#### REMARKS

Title: Plate Handling with Thermal Tensioning Inventor(s): Theriault et al.
Serial No. 10/643,036
Atty Docket No. PTK-228 Atty: Steven J. Frank Annotated Marked Up Drawing Sheet 2 of 2

FIG. 2

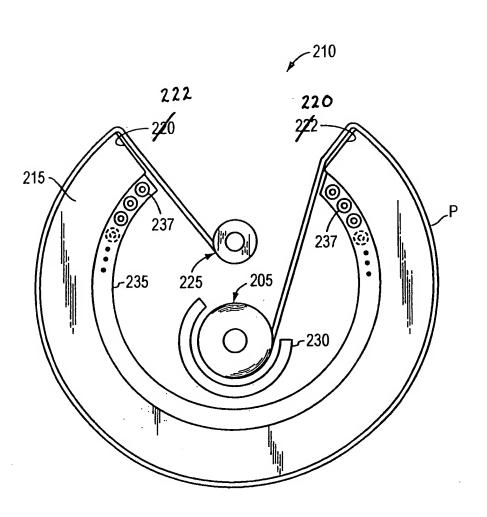
Applicants amend Figure 2 to correct two typographical errors in which the original label reference number 220 is replaced by label 222 and original label reference number 222 is replaced by label 220. Applicants submit herewith replacement drawing sheet 2 and a marked up drawing sheet 2 reflecting this amendment. Applicants submit that no new matter is introduced by this amendment.
